### APPEAL SUMMARY

**Status:** Decision Rendered - Reconsideration of ID 27668

<b>Appeal ID:</b> 27739	<b>Project Address:</b> 1735 E Burnside
<b>Hearing Date:</b> 5/11/22	<b>Appellant Name:</b> Thomas Ellicott
<b>Case No.:</b> B-005	<b>Appellant Phone:</b> 5035488674
<b>Appeal Type:</b> Building	<b>Plans Examiner/Inspector:</b> Catherine Heeb
<b>Project Type:</b> commercial	<b>Stories:</b> 3 <b>Occupancy:</b> A-2 <b>Construction Type:</b> VB
<b>Building/Business Name:</b> Gold Record Hi-Fi Bar	<b>Fire Sprinklers:</b> Yes - full building
<b>Appeal Involves:</b> Addition to an existing structure, Reconsideration of appeal, occ Change from Mixed B-R2 to A2	<b>LUR or Permit Application No.:</b> LU# 21058141 DZ
<b>Plan Submitted Option:</b> pdf [File 1]	<b>Proposed use:</b> Nightclub

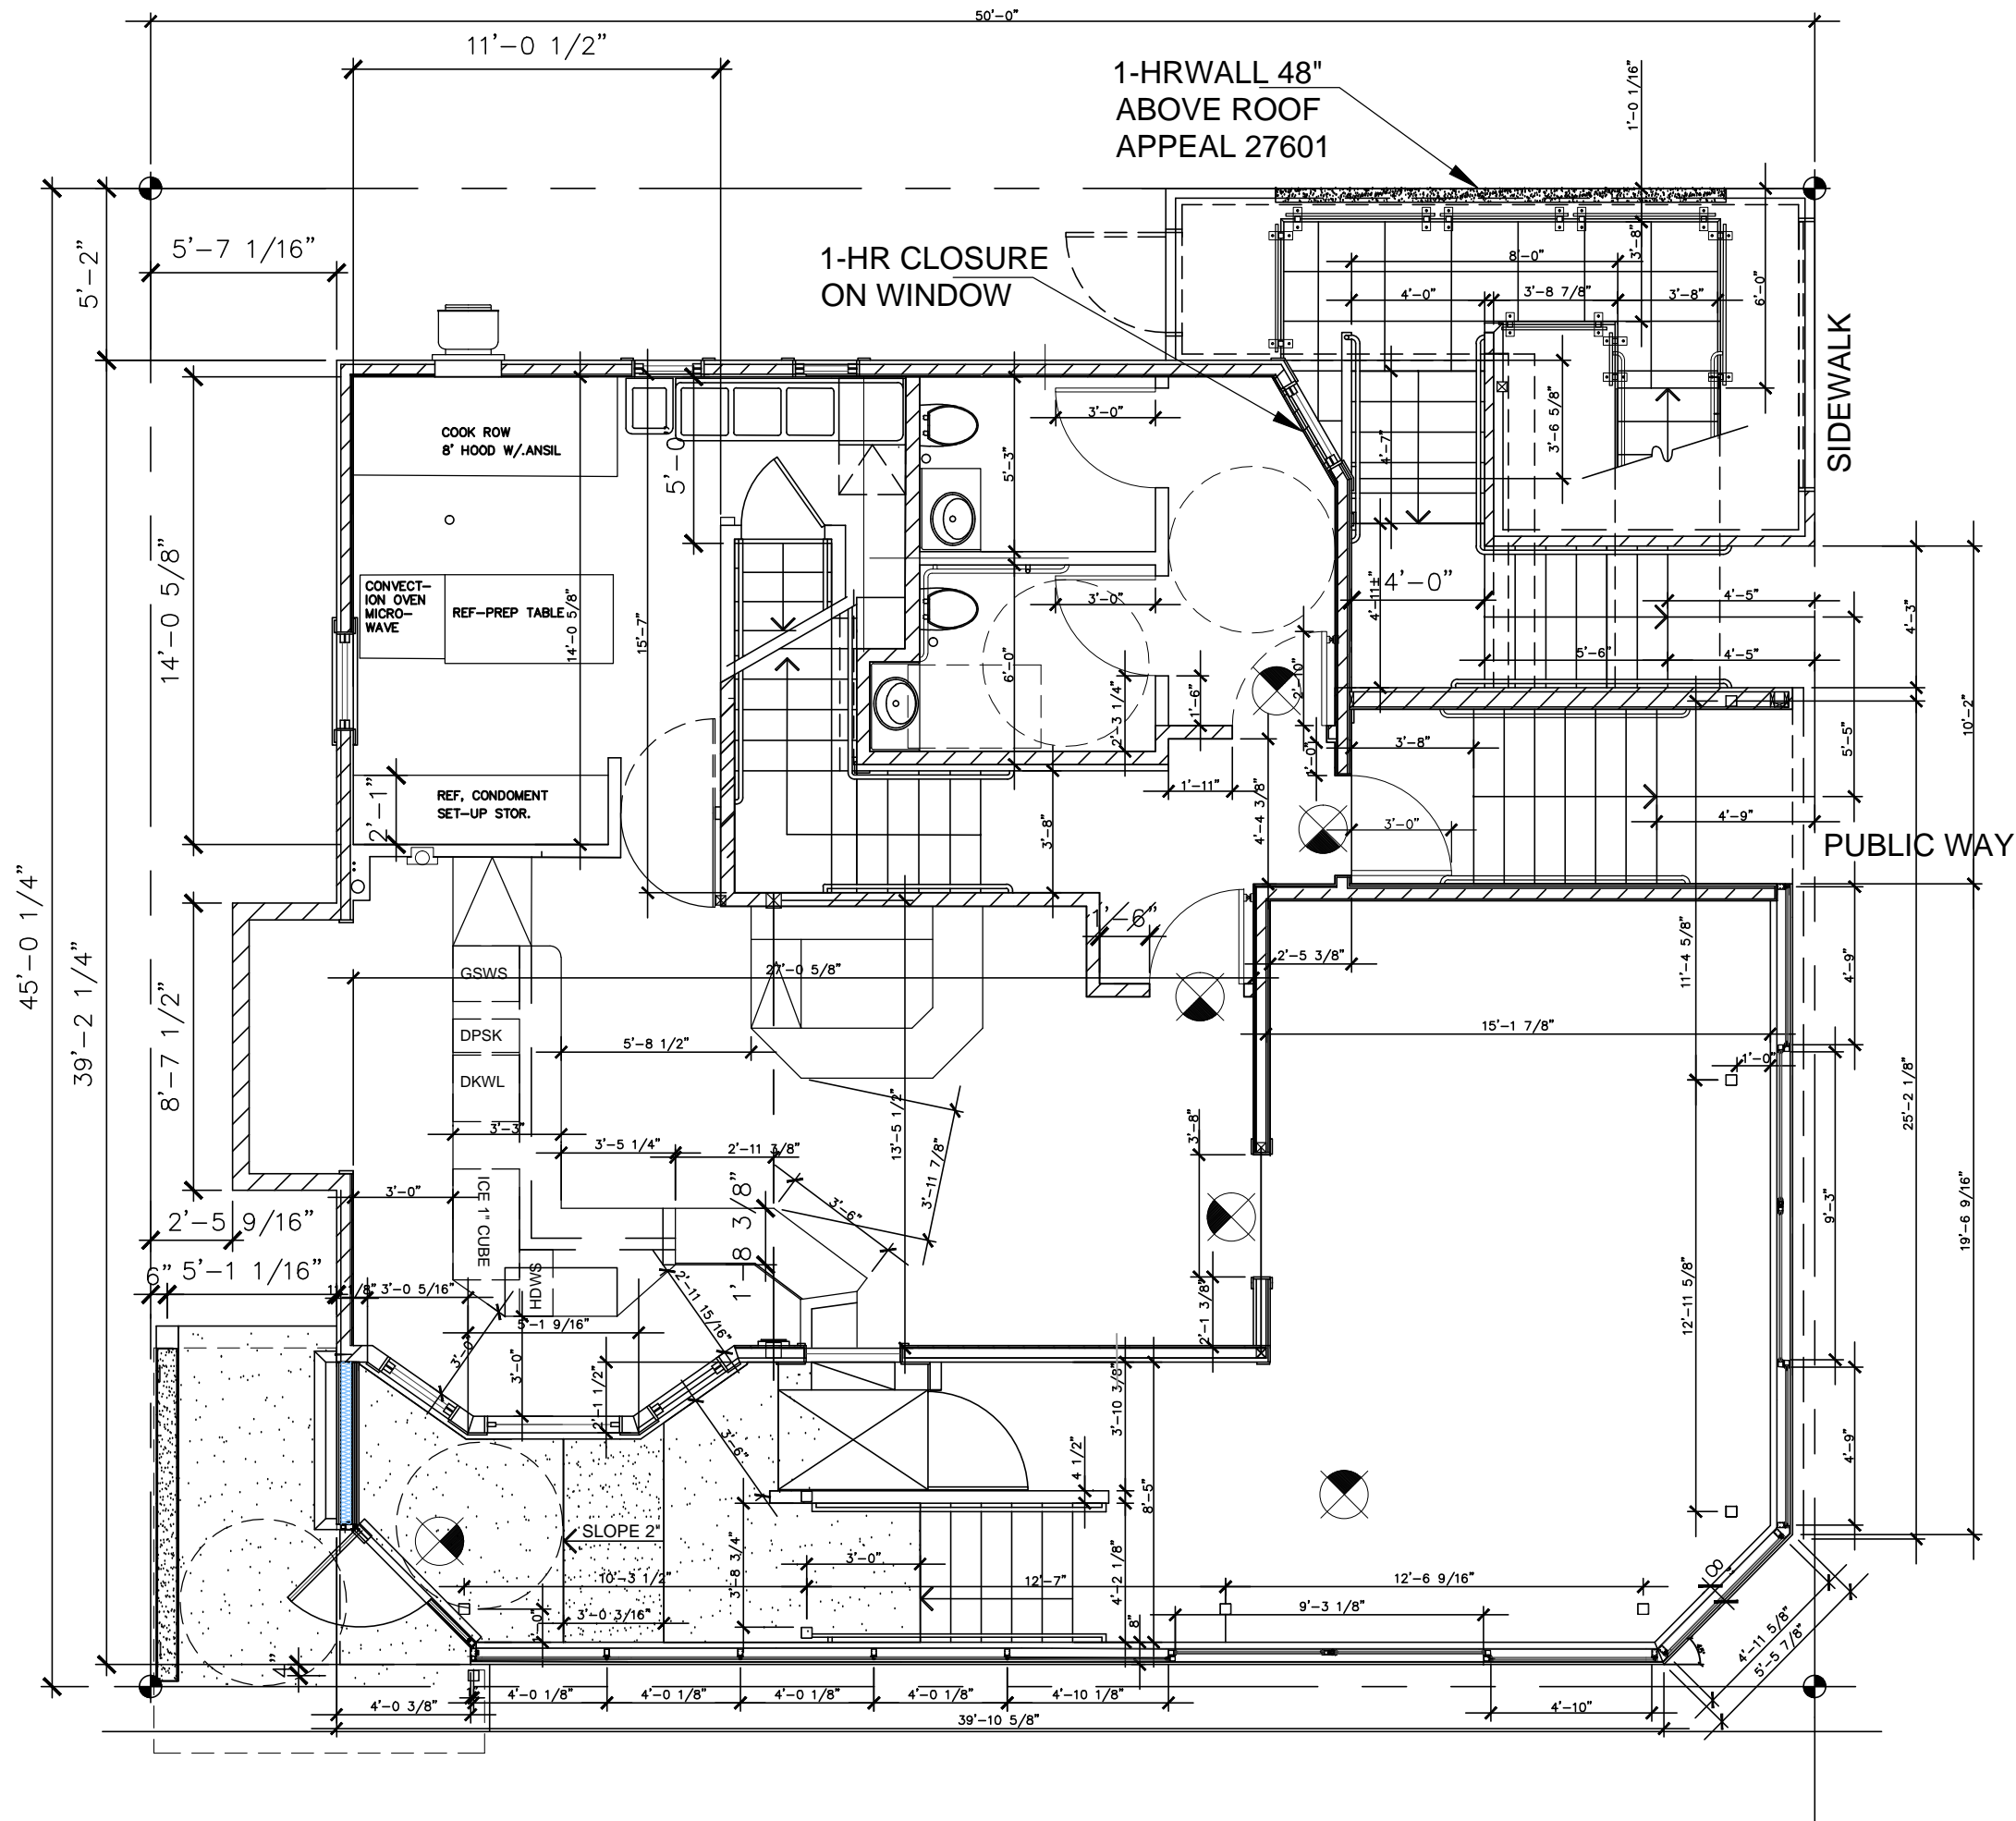
**Code Modification or Alternate Requested** Our intent is to correct the convergence of the two exits from a single exit discharge to provide a separate path of travel for the interior stair shaft and the exterior deck exit systems and meeting the required exit width for the occupant's two exit stair systems.

**Proposed Design** It appears that the first-floor occupants should depart the build prior to the arrival of the 2nd and 3rd floor occupants. "Because of this idea a convergency on the exit porch and exit-passage requires the following evaluation method for equivalent safety. The equivalent of the exit width is: 3rd flr-4p(.5)=2 occ., 2nd flr-82p(.5)=41occ., 1st flr-64p(.5)=32occ. The total occupant passage width at 2+41+32=75(.3) = 22.5 inches and the exit passage width is 51"(.5)= 26" therefore not exceeding 50 percent of exit passage width. The deck has two exits, people can inter the building because it is the same activity. Additional safety for the exit discharge is by making the walls that enclose the open air passage rated 2hrs (WP8415 or ULU301) for the 10-feet of distance to the public way. Installing 2 side walls, fuse-link sprinkler heads in the south exterior wall (Exception 1.3) will be added. The 20 SF porch landing is sprinkled and rated 1hr.. Emergency lighting is already required in the porch and will be installed in the exit discharge.

"Reconsideration Text". The attached plan A1.3 shows the revised design which removes the convergency of the interior stair shaft's building exit and the arrival of the second floor deck exit passage way to the same porch land. The two exits, exterior deck stairs and interior stairs, each have a separate exit discharge to the public way. Each exit discharge has a 1hr separation to the public way. Section 1027.5, requires the exterior exit stairways to have a fire separation distance of 10 feet measured at right angles from the exterior edge of the stairway's discharge, this distance is shown on the attached plan.

**Reason for alternative** Our revised design removes the convergency of the two exit stairs into a single exit passageway to the public way. The new design increases life safety by providing two separate exits to the public way with 1-hour separation and the required fire separation distance at the point of discharge onto the sidewalk or public way.

**1. Exiting from 2nd floor: Granted provided the walls and lid meet exit passageway requirements.**

**2. Exit discharge to exterior of building: Granted as proposed.**
